**APPLICATION FOR A CERTIFICATE OF APPROPRIATENESS FOR
A SIGN IN A SPECIAL PROVISION SIGN DISTRICT (SPSD)**

UPTOWN SIGN DISTRICT

CASE NUMBER: SIGN-26-000804
LOCATION: 2508 MAPLE AVE
(SOUTHEAST CORNER)

REQUEST: An application for a Certificate of Appropriateness by Curt Horak of Priority Signs, for a 92-square-foot LED illuminated detached sign at 2508 MAPLE AVE (SOUTHEAST CORNER).

FRONT VIEW
SCALE: 1/2" = 1'-0"

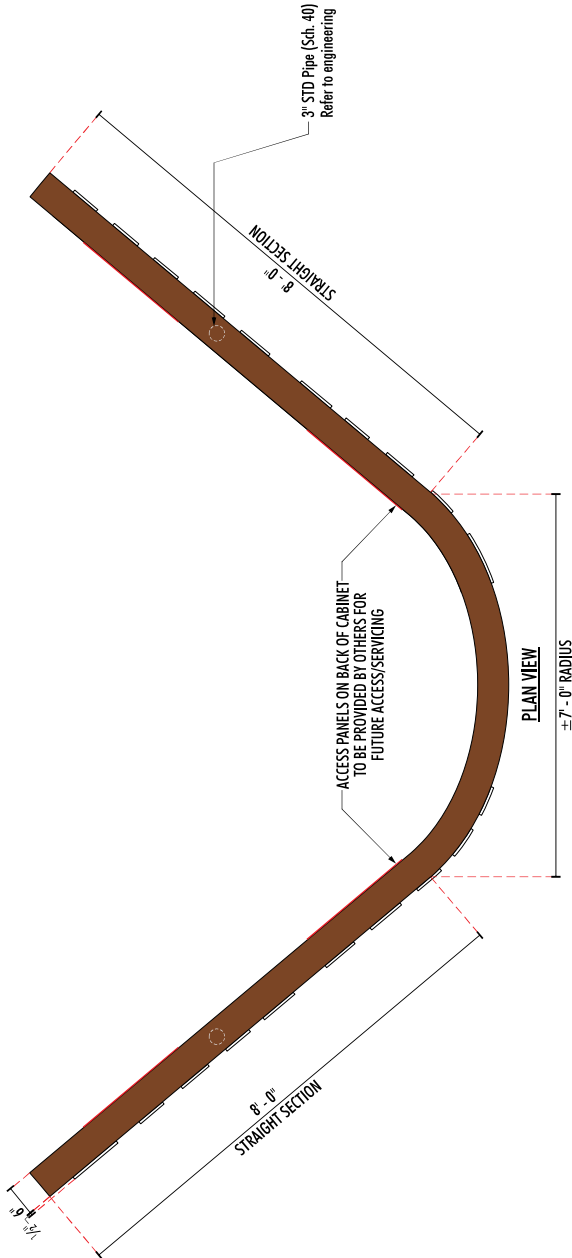
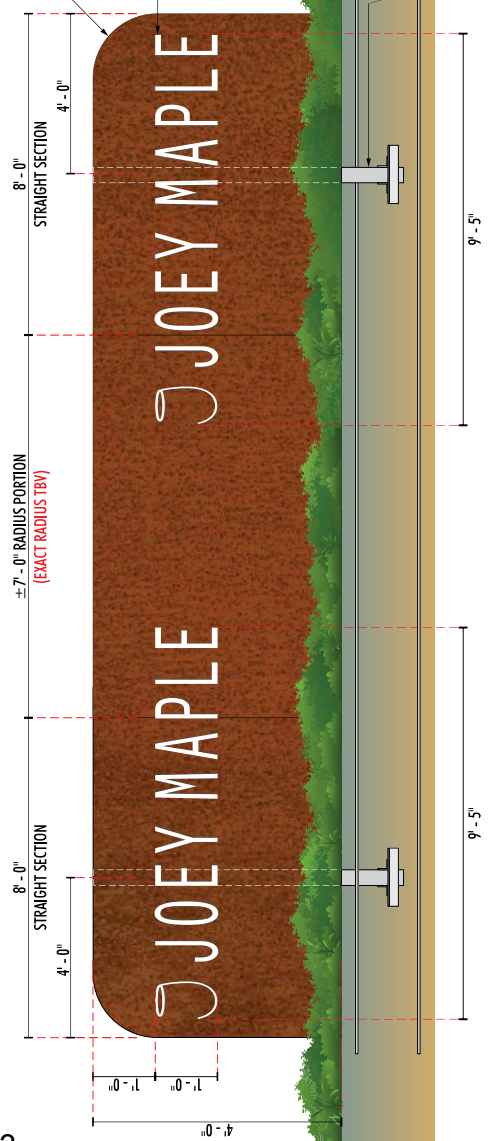
This use of push-thru acrylic letters complies with this article.

This is the only detached sign proposed for this site. The setback is five-feet, height does not exceed four-feet and the effective area does not exceed 92-square-feet.
